From: Se Jin Kwak <se.jin.kwak.work@gmail.com>
Sent: Thursday, April 10, 2014 9:26 AM
To: Scala, Mary Joy
Subject: Re: Gas Tank Enclosure for Hemoshear

HEMOSHEAR
 OFFICE & LABORATORY
 494 LOCUST AVENUE
 CHARLOTTEVILLE, VA 22902

FEB. 28, 2014
A0.1
 TANK ENCLOSURE

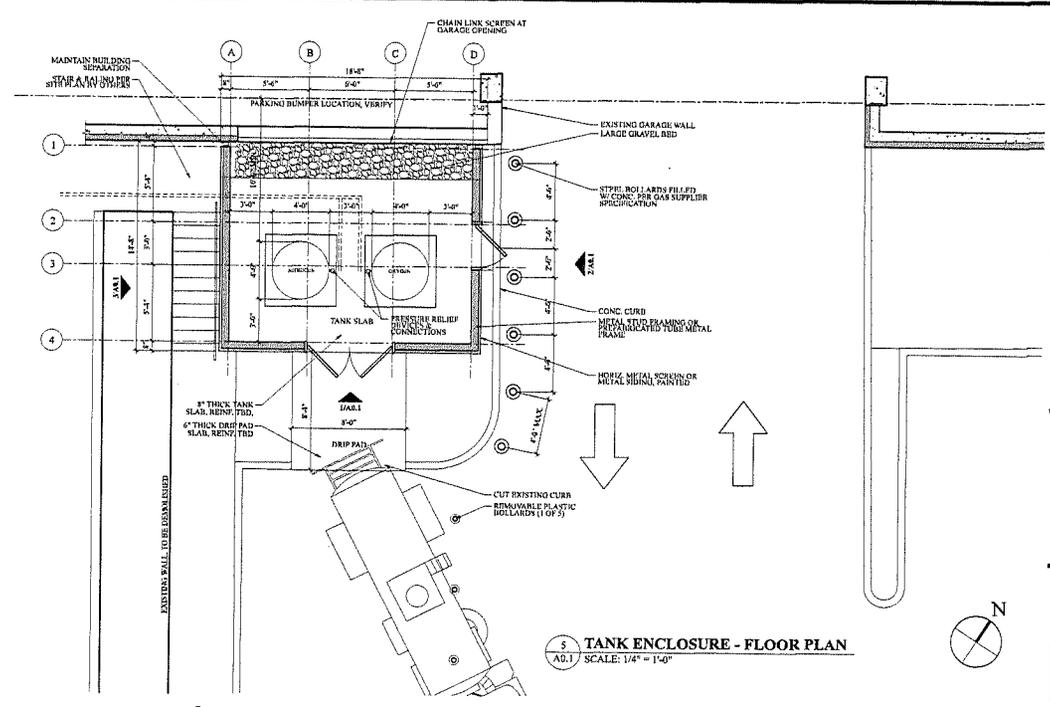
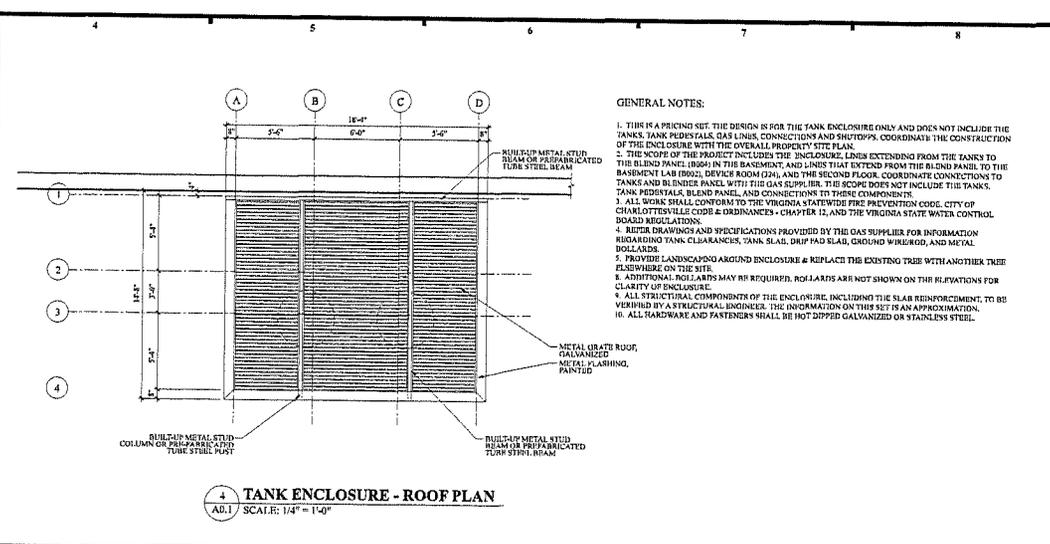
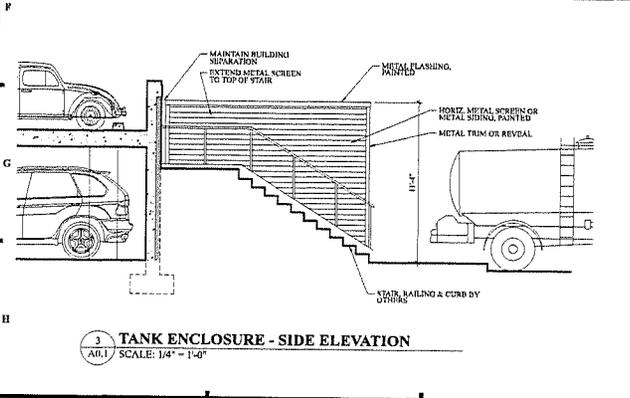
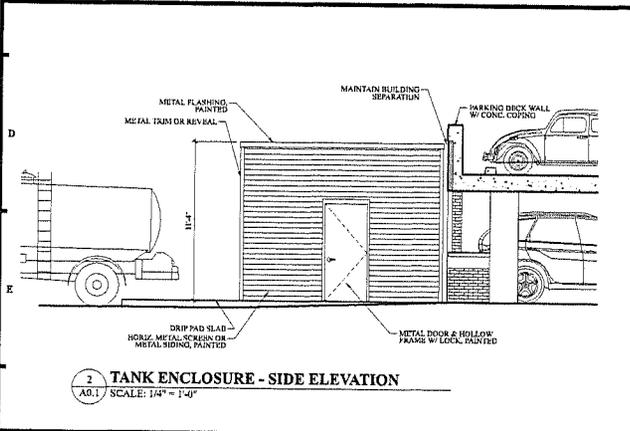
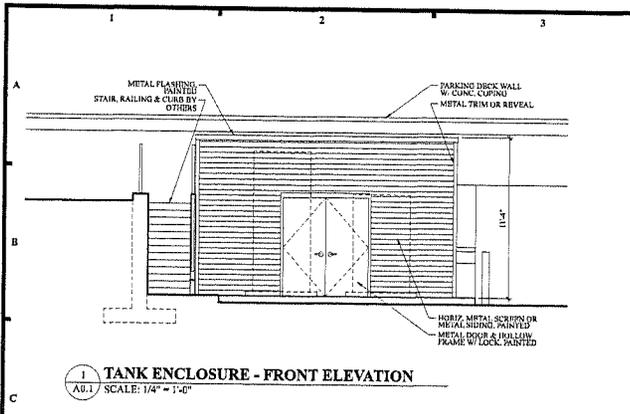
Yes I would like to know the final choice for material.

Here are the revised drawings for the tank enclosure with the metal screen/siding extending to the top of the slab. The final screen product is yet to be determined but I will get you that information once it is selected. Is that something you would like to review? The screen color will be similar to brick.

I admit the chain link enclosure was a long shot but I had to try. The cost of this work came as a surprise to us and the enclosure was the only thing where we could find savings. What do you think about extending the original horizontal metal screen enclosure down to the floor slab, and eliminating the low masonry wall? The original is attached. This will be discussed at the meeting today and I wanted to get an okay before I get into the redesign.

> Chain link is not an acceptable material in a design control district. Suggest something else.

I am not going to require a separate COA permit for the enclosure. I think that will be fine as you describe. Do you still intend to paint it a brick color?

Yes I think that material would be fine.
